## Customer Service Bulletin Commercial Business Group

### Workman<sup>®</sup> 4200 and 4300 4wd

<b><u>Model/Serial Range:</u></b>	<b><u>Model Number:</u></b>	<b><u>Serial Numbers:</u></b>
	07215/07216	50001-59999

**Subject:     Steering System change.**

# WORKMAN® 4WD STEERING SYSTEM CHANGES

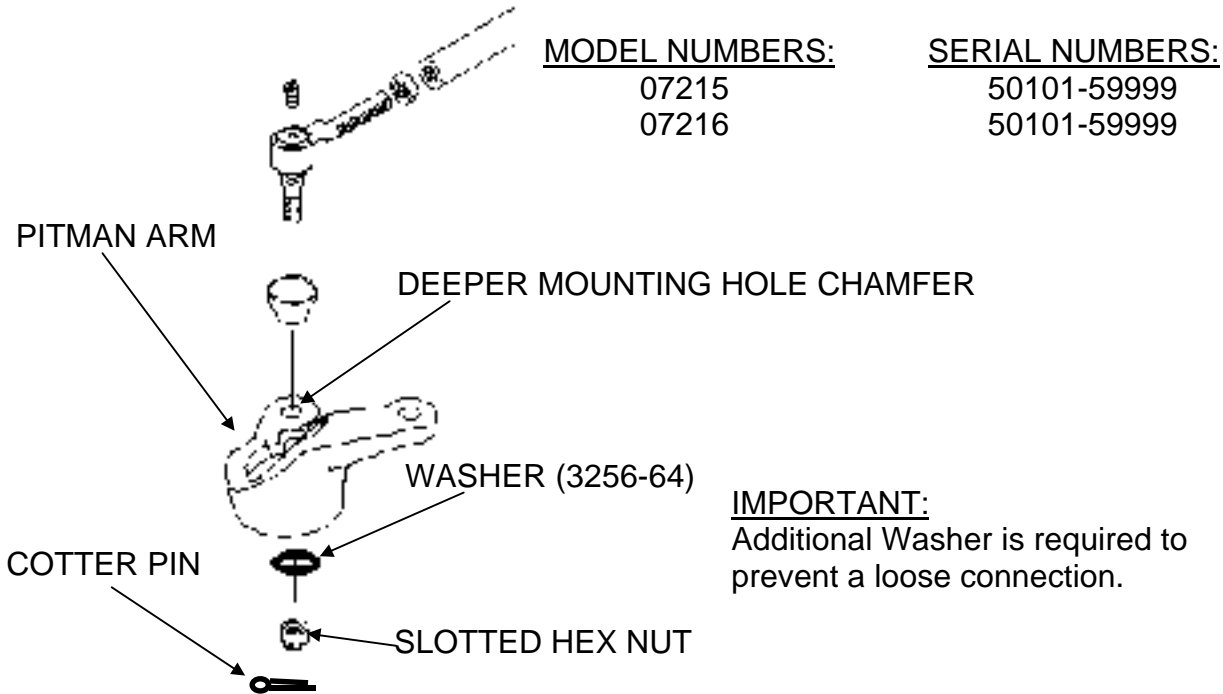
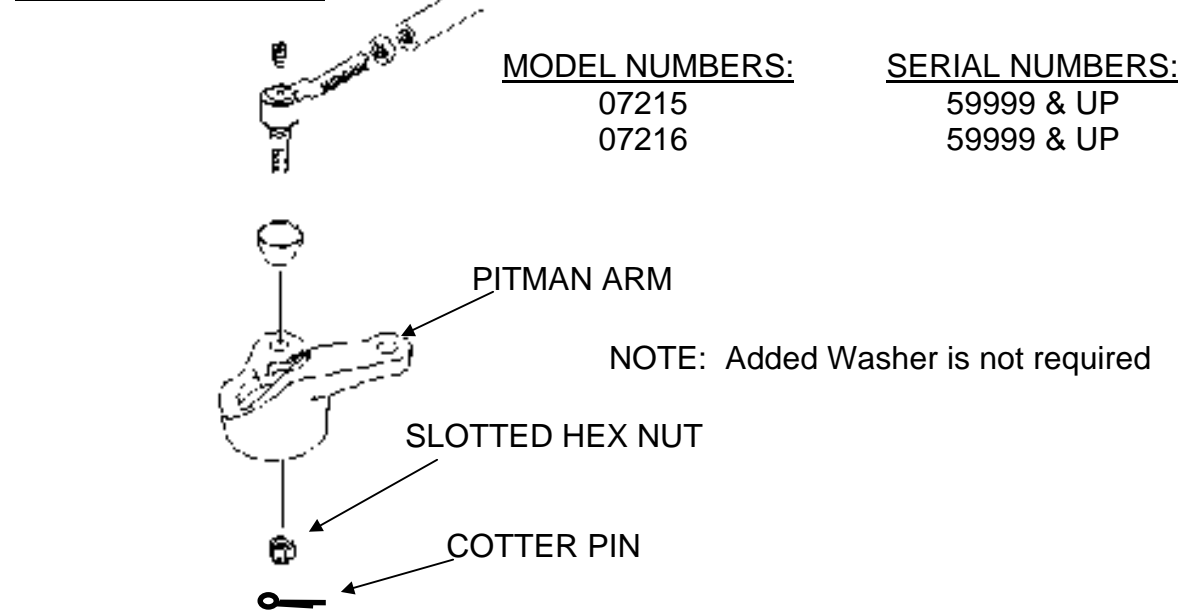
Machines in the serial number range listed above were manufactured with a modified Pitman Arm. The arm was modified with a deeper taper of the tie rod mounting hole to provide clearance between the tie rod and grease fitting. These machines require a flat washer between the castle nut and Pitman Arm as a result of this modification that may not be shown in the Parts Book. This washer must remain in place to ensure the tie rod can be properly tightened. The attached page identifies this change in more detail.
